ADDENDUM NO. 1

Re: **GS# 103-292**
Campus Roofing (Liberal Arts Building)
Jackson State University
Jackson, Mississippi

EXHIBIT "A"
 SHEET 1 OF 1

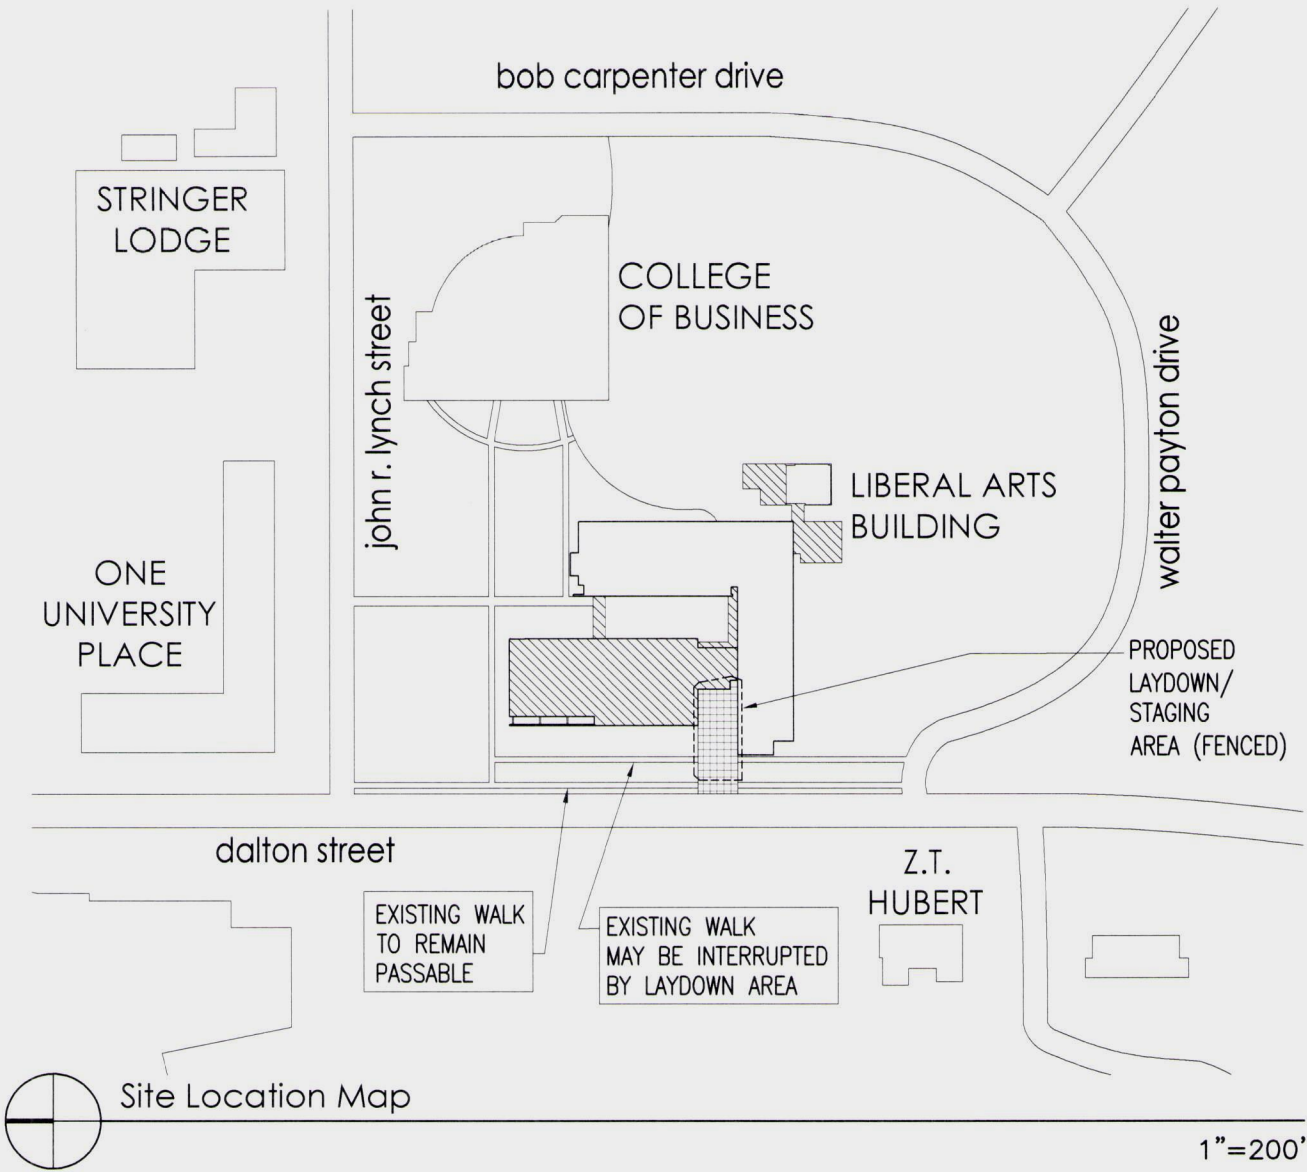
- Item No. 1:** A proposed laydown/staging area for the project is the paver plaza on the west side of the building. If Contractor elects to use this plaza for staging, it shall be appropriately fenced for protection of faculty, students, and staff who may be near this building, and the pavers shall be appropriately protected with plywood, timbers, etc., during construction. The laydown area may interrupt the inner (east) north-south sidewalk, but not the west north-south sidewalk that is adjacent to Dalton Street. See attached Exhibit "A".
- Item No. 2:** Project sequencing and scheduling are very important, as this roofing project affects important subsequent projects that are critical to the occupancy of the building. The main roof(s) (Roofs A-E) shall be roofed before the mechanical room roofs (Roofs F-H).
